Intel Bay Trail-M Platform Block Diagram

PROJECT : Peach
Quanta Computer Inc.

Size Custom	Document Number Valley 2/9 (DDR8)	Rev 1A
Date: Saturday, May 24, 2014	Sheet 3 of 40

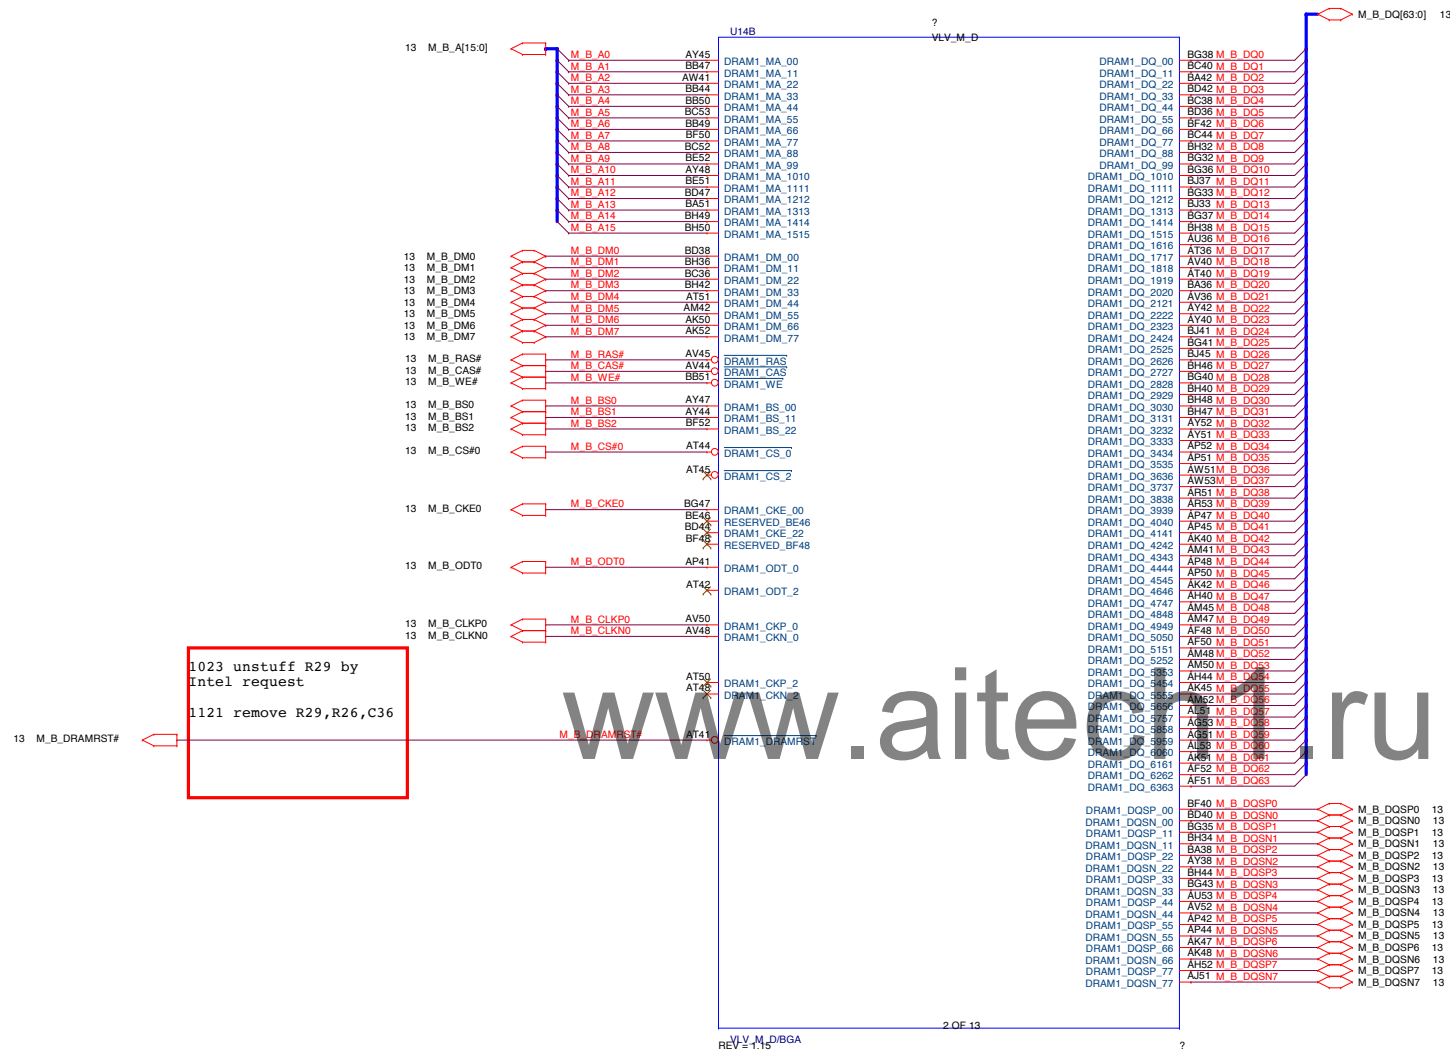
```
1023 unstuff R28 by
Intel request
1121 remove R28,R25,C35
```

BTM Strapping Table

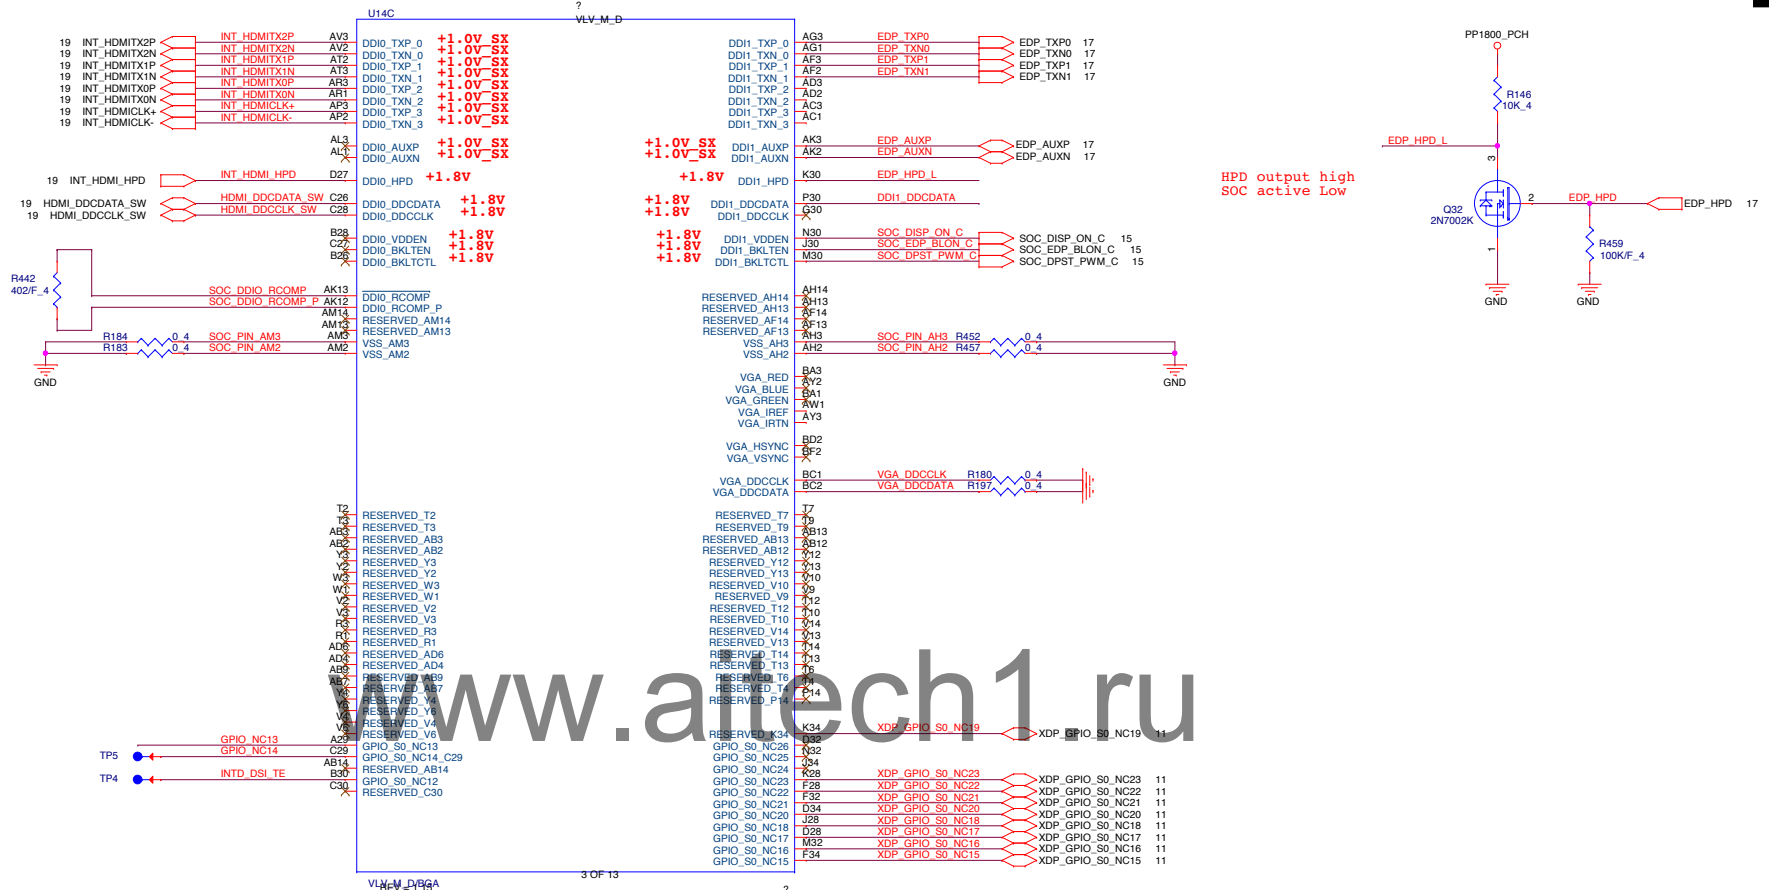
1029 unstuff R128, using SoC internal PU

1029 unstuff R372, using SoC internal PU

1115 stuff R372, system can't boot if un-stuff R372 on proto1.5 board, need intel double confirm before proto2

1029 unstuff R386, using SoC internal PU

1115 stuff R386, it is required

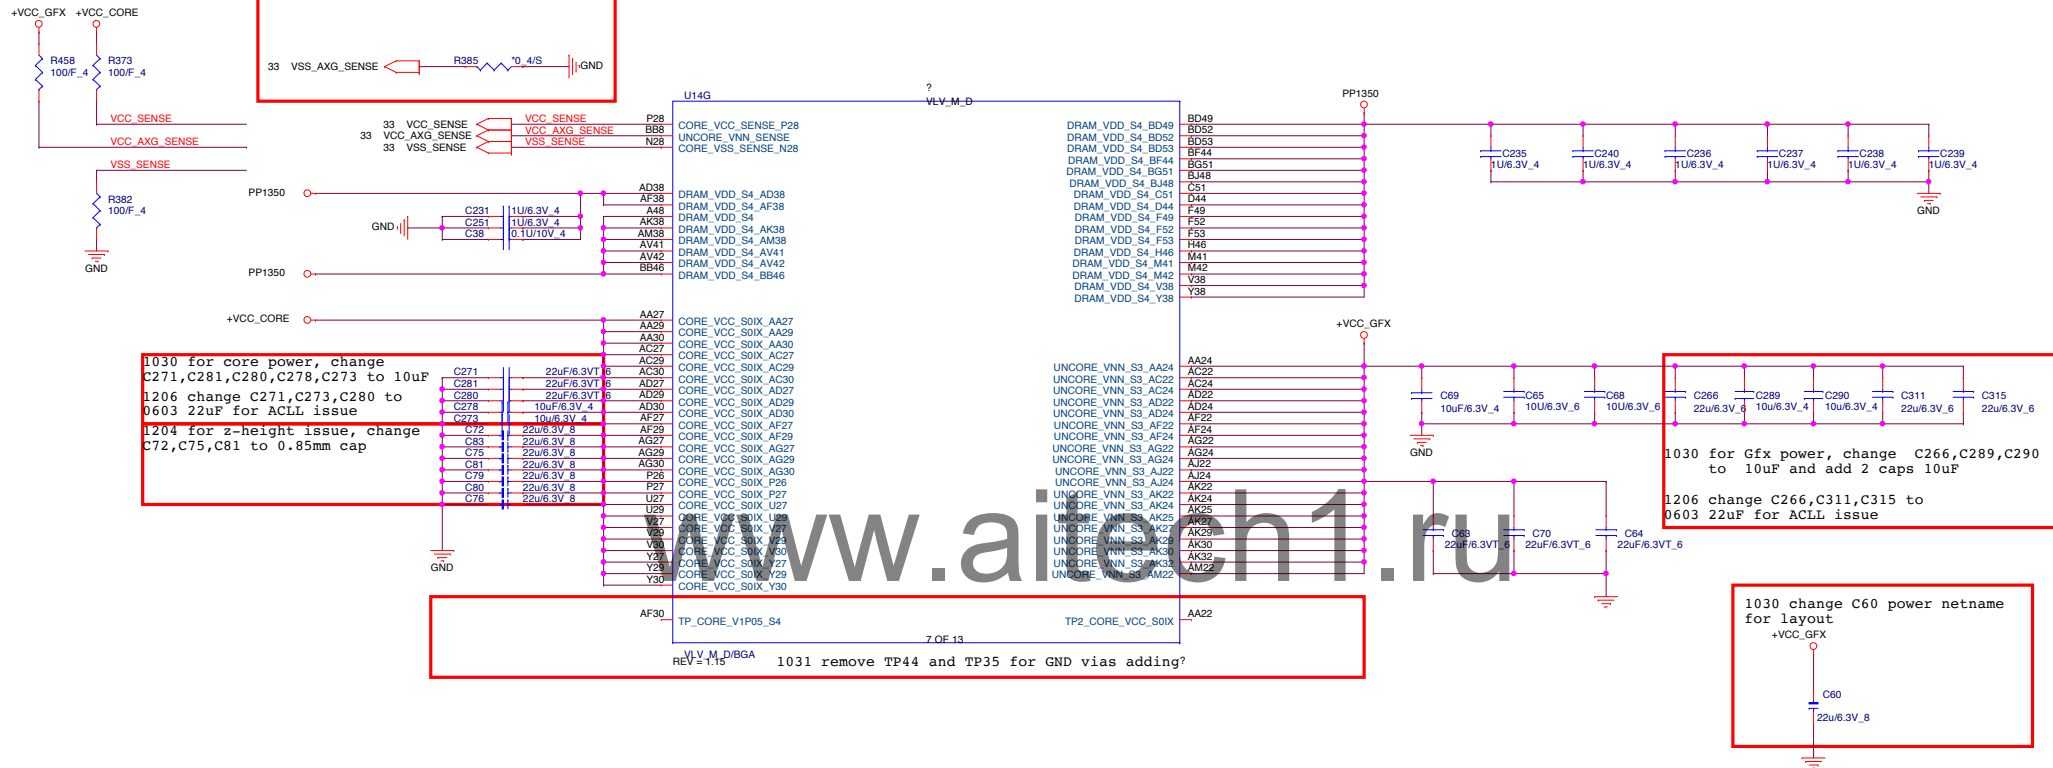
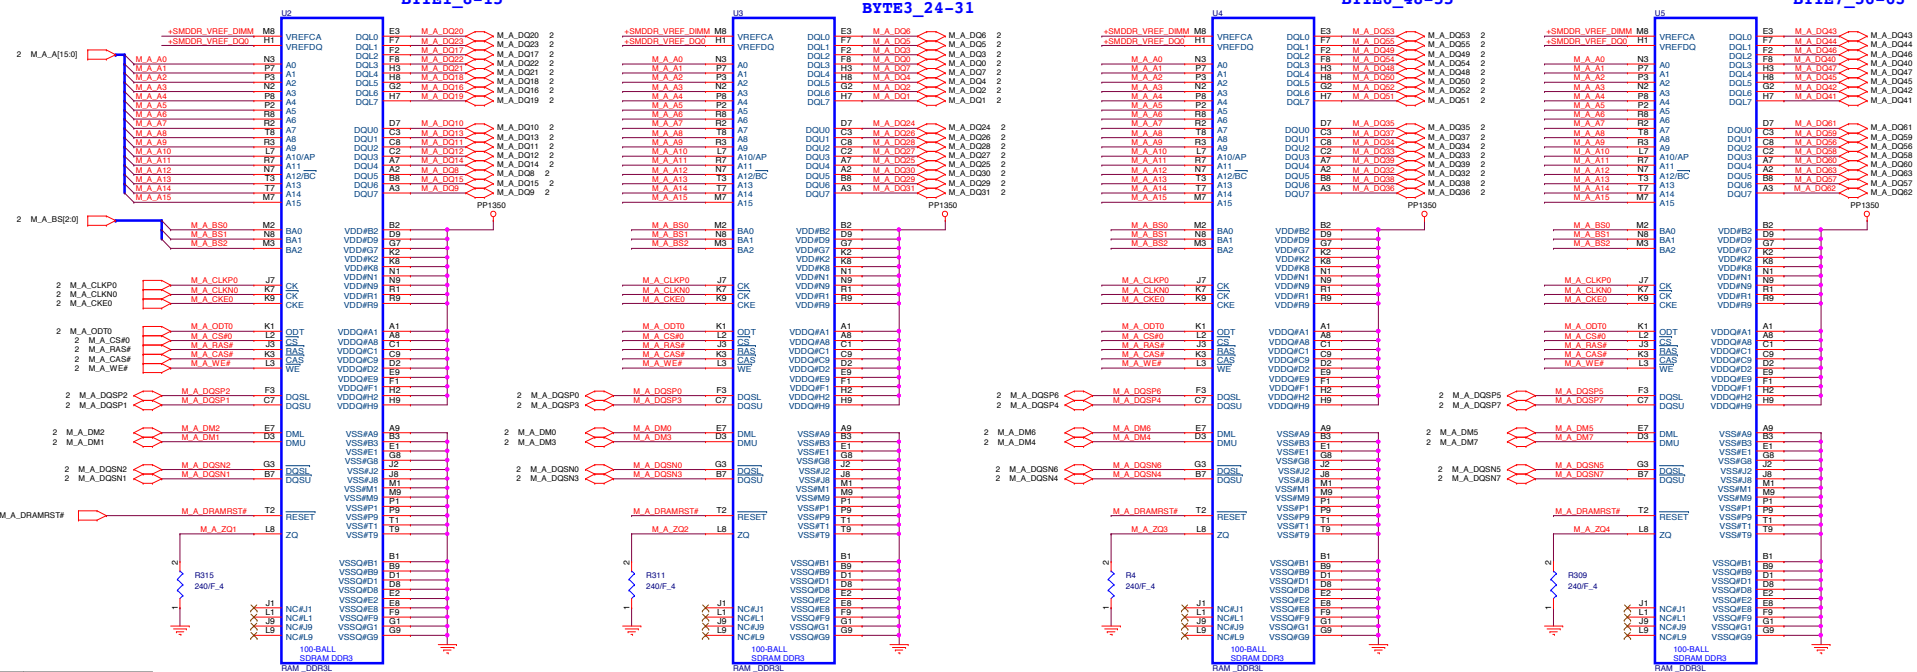
1031 for layout suggestion by intel, VSS_AXG_SENSE didn't connect to VSS_SENSE, will connect the GND via near VCC_AXG_SENSE
1031 for layout, add 0hm between GND and VSS_AXG_SENSE

1205 add 0.1uFx2 on PP1350 for EMI request

1024 change ODT PU to VTT by Intel request

PWRON SEQUENCE

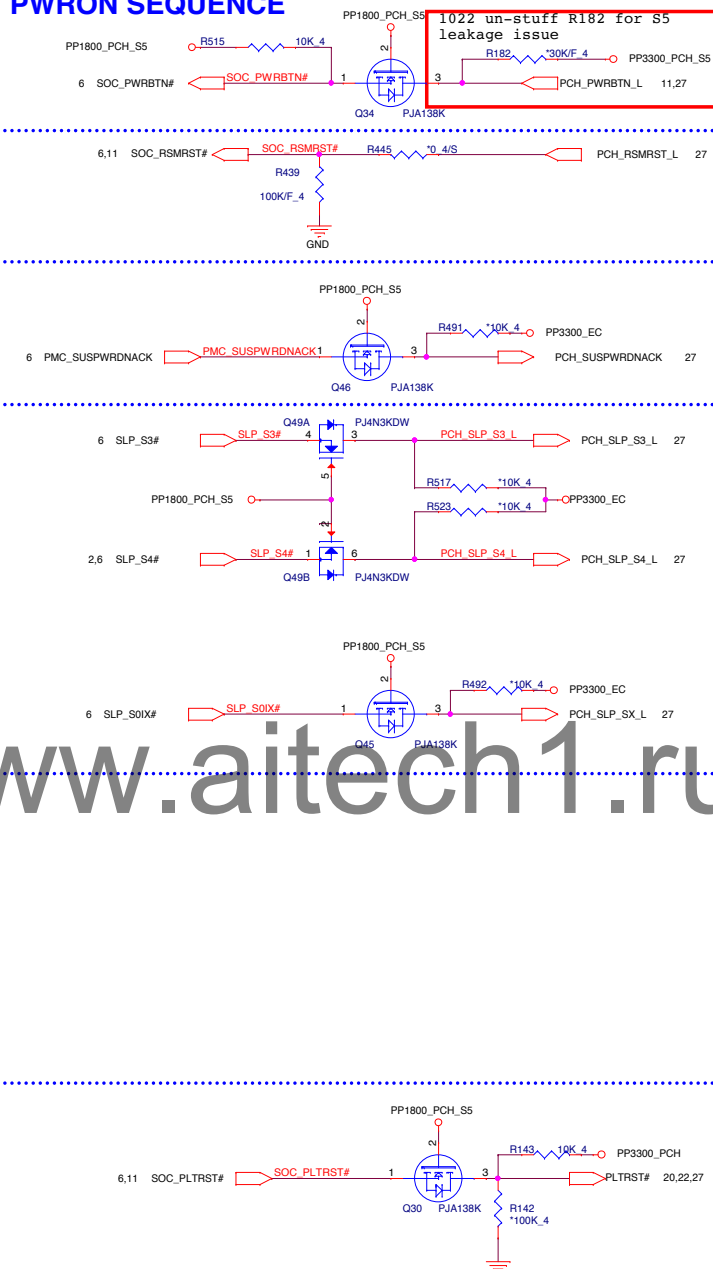
0220 remove SPI_SIO Interface,
Q35,Q36,Q37,Q44,R486,R484,R485,
R483,R426,R429,R427,R428

S0iX Power Good

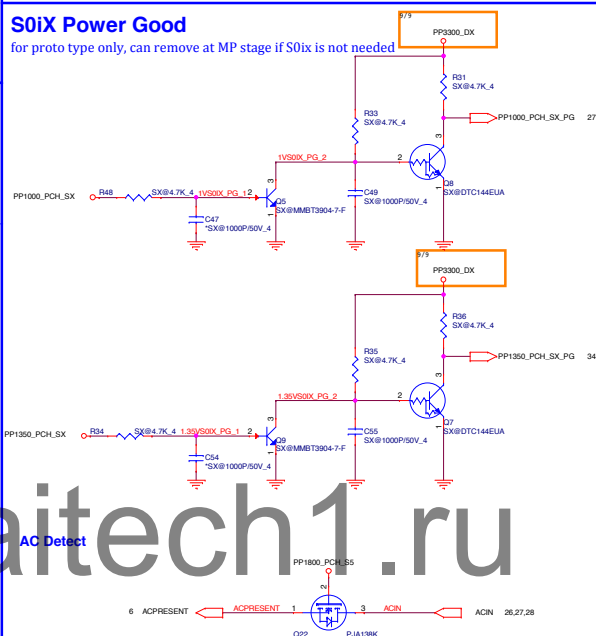
for proto type only, can remove at MP stage if S0ix is not needed

EMMC (CBS)

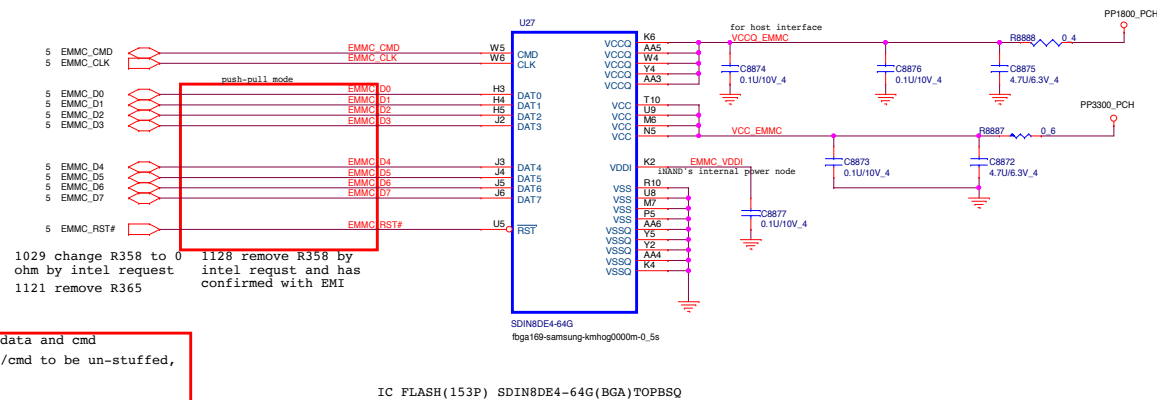
1029 remove pulled up resistors for eMMC data and cmd
1211 add back pulled up resistors
1212 all Pulled up resistors of eMMC data/cmd to be un-stuffed, and R361 change to 47K ohm as well

Audio Jack

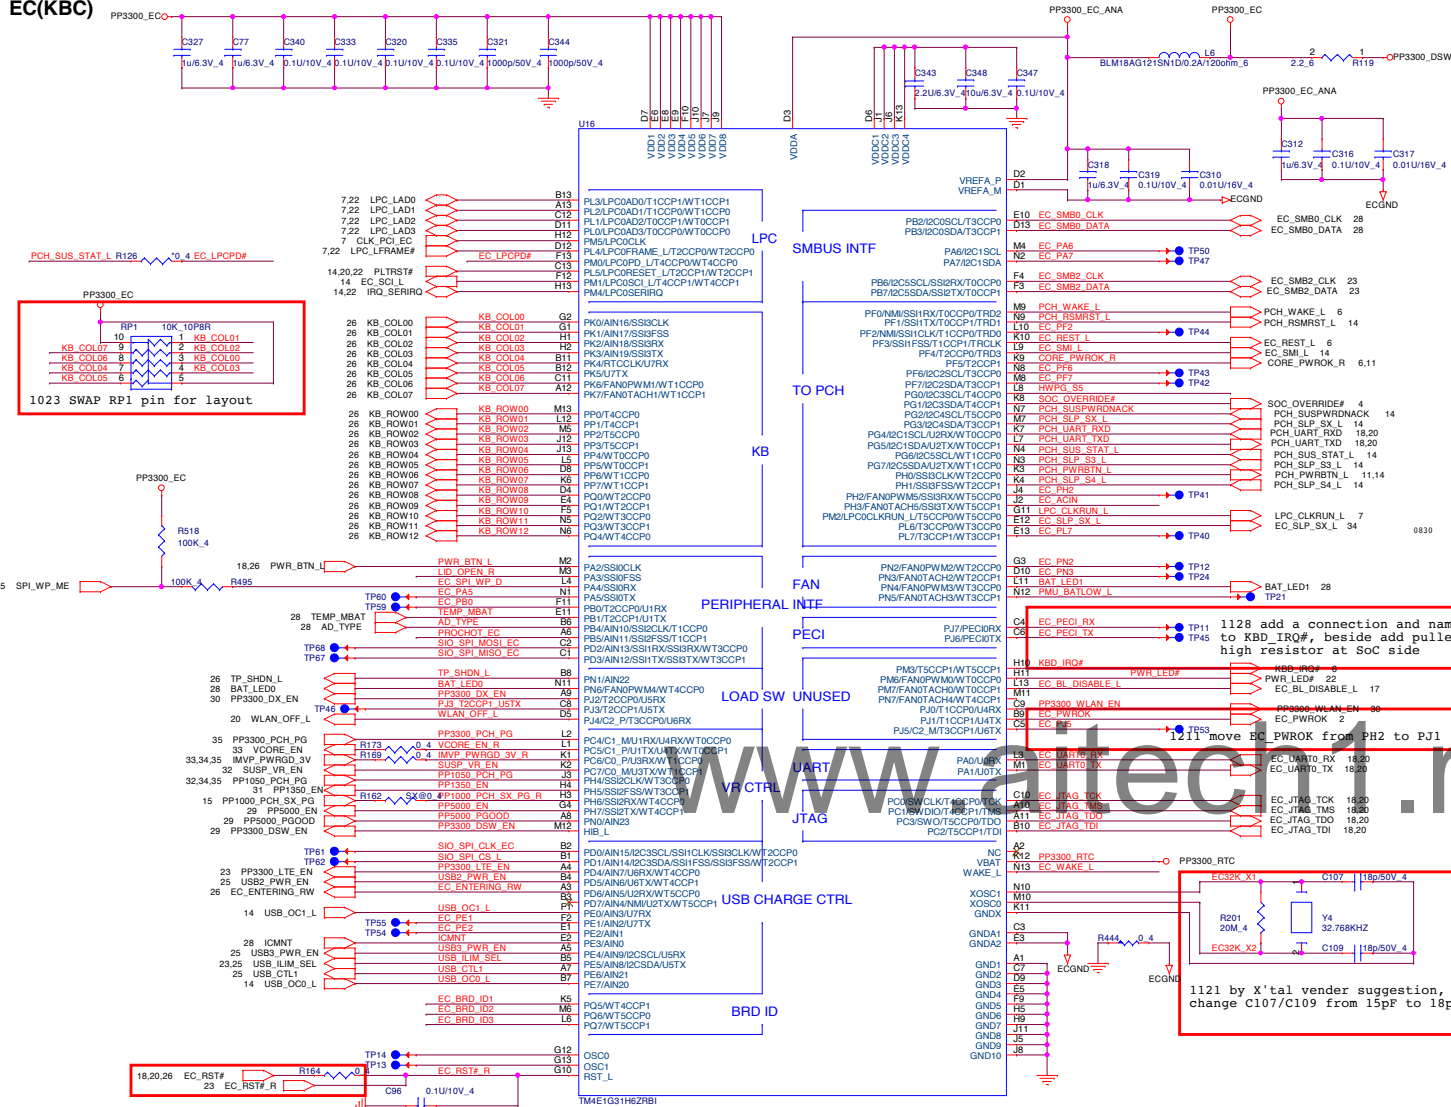
1025 change
headphone footprint
and PN, need check
pin out again

1025 remove pin7

1026 change jack
same as peach1.0
